STAFF REPORT: OCTOBER 11, 2023 MEETING

APPLICATION NUMBER: HDC2023-00024

ADDRESS: 2244 WABASH

**SCOPE: DEMOLISH REAR OF HOUSE* (WORK COMPLETED WITHOUT APPROVAL);
ERECT REAR ADDITION**

CC 2244 Wabash5 11-14-22 Jaafar.JPG

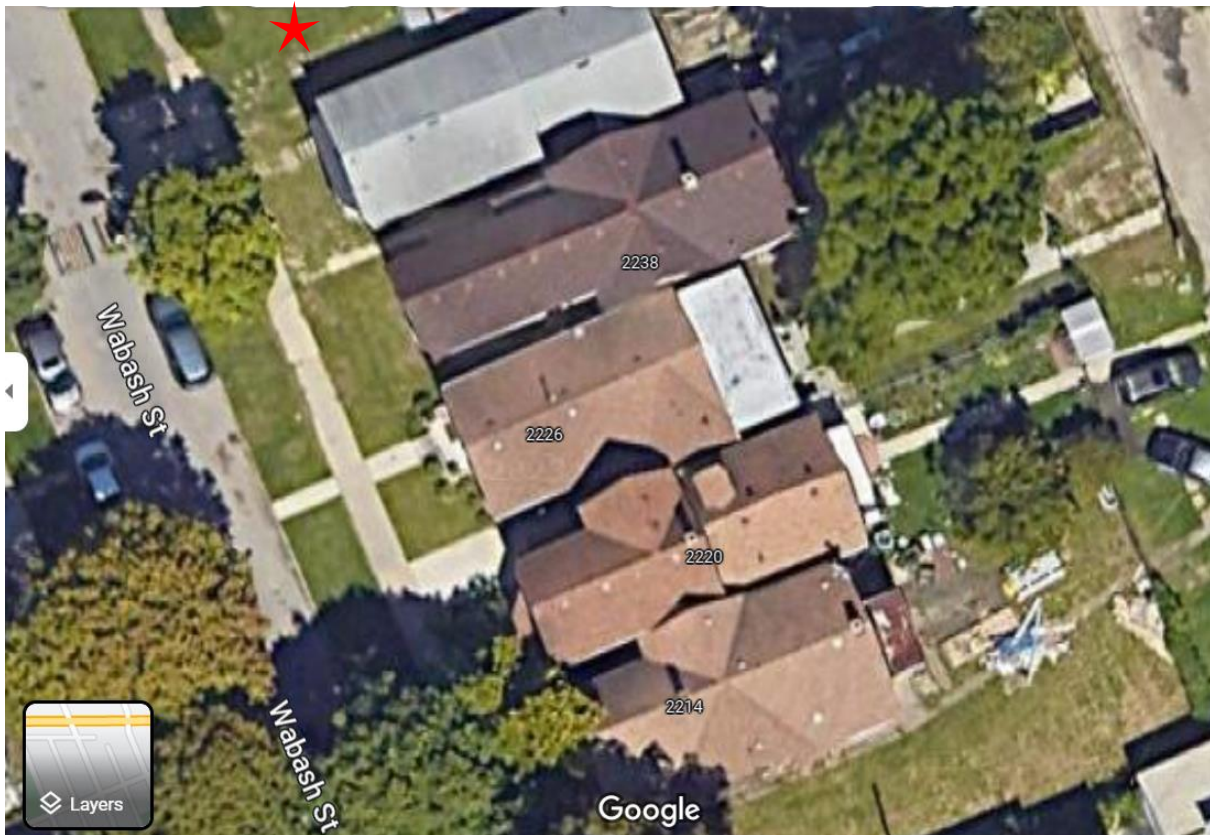
Staff obtained photos from BSEED's Dangerous Buildings Division that show the condition of the rear wall prior to the recent demolition of the rear section of the house. This view shows the historic gable's wood sheathing and rake board were intact. Staff believes this section of the house could have had temporary support while the structural issues were corrected.

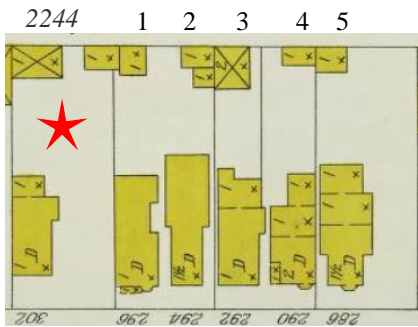
- The applicant states the new design is to duplicate the neighboring homes as a style and size reference. The Standards do not allow for a house to be changed to match other houses; a house must remain a product of its time and its individual architectural design. Beyond that, the previous footprint did match the neighboring homes that were built within the same 19th century time.

On the following page is an expanded view of the 1897 Sanborn map which shows that neighboring five dwellings had inset or extending walls and all but one had (and still have) cross gabled roofs.

Google aerial image. 2244 Wabash is not visible but is directly above where the star is located. This view shows how four of the five houses have cross gable roofs, many of which cover extending walls (identical to what was in place at 2244 Wabash). The photos on the following page offer streetscape views of the above dwellings.

- The applicant states the new design is to duplicate the neighboring homes as a style and size reference. The Standards do not allow for a house to be changed to match other houses; a house must remain a product of its time and its individual architectural design. Beyond that, the previous footprint did match most neighboring homes that were built within the same 19th century time period. The side wing should be reconstructed as part of a new construction proposal.

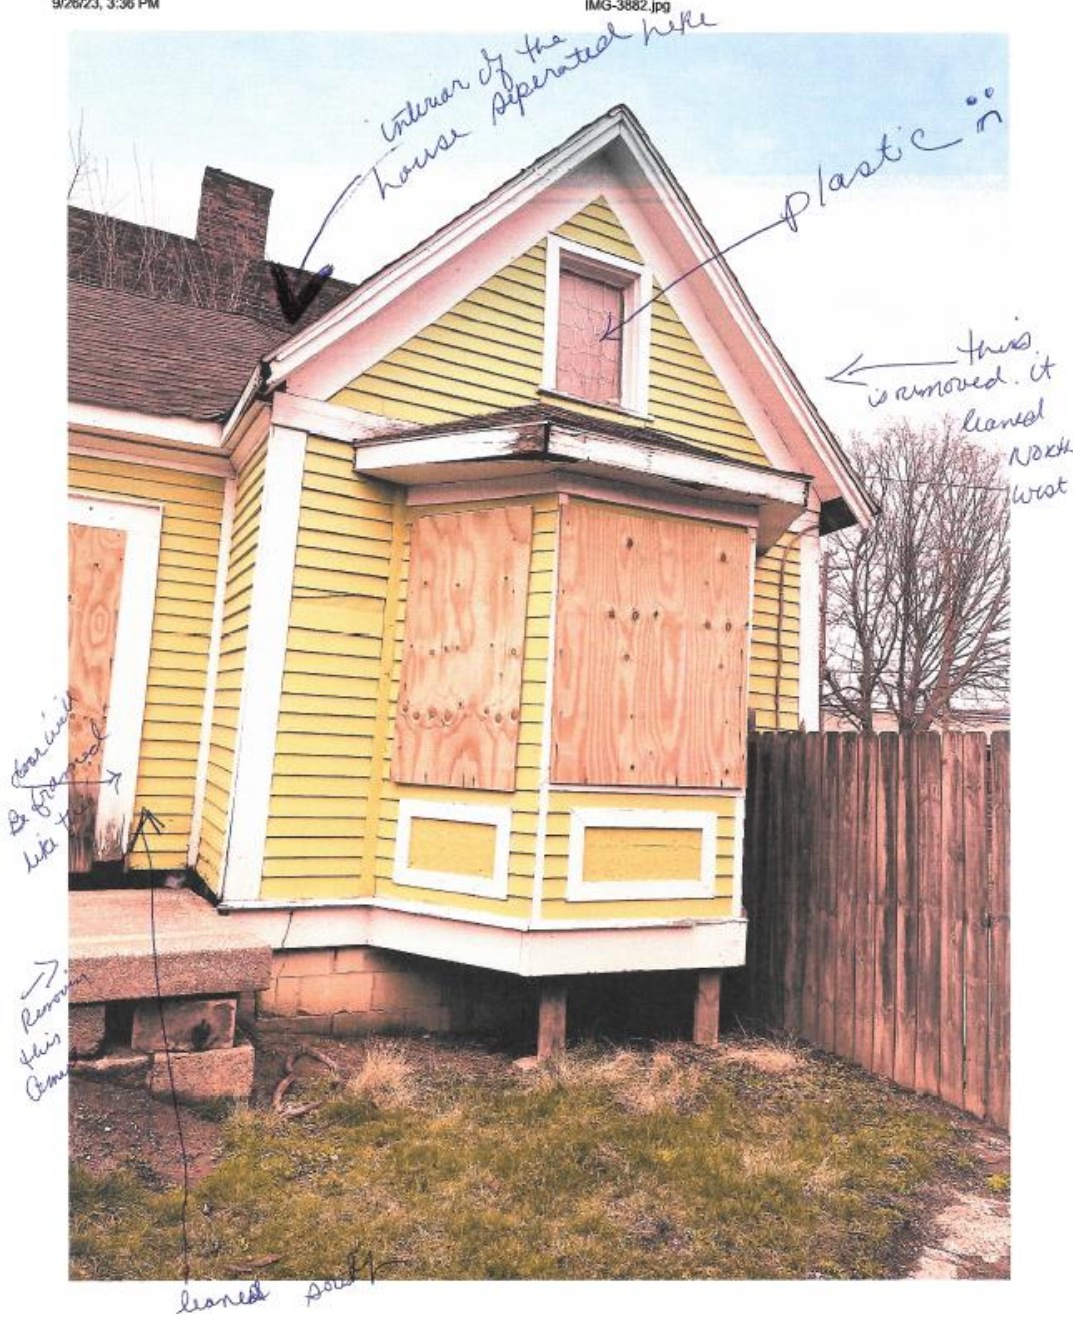
Drawings submitted by applicant. The drawing above doesn't show the door that will be retained at the south (bottom) wall, and the drawing at right should be used as an indication for massing only. The majority of window and door openings, as well as the proposed south elevation porch, are not shown.

- The submitted documents do not clearly show how the house and lot will look with the proposed rehabilitation and new construction, and different dimensions for the addition are mentioned in the varying documents. A landscape plan, dimensioned site plan, and dimensioned elevations are necessary to review the proposal for its placement on the site as well as showing how the walls, window and door openings, new porches, exterior siding and trim and landscaping will be articulated. Staff sent multiple requests for detailed documents but only received additional hand drawings and marked-up photos.

- Detailed, dimensioned drawings that would adequately convey the finished appearance of the house and lot were not submitted, therefore the Commission can't review the proposal beyond the work completed without approval.
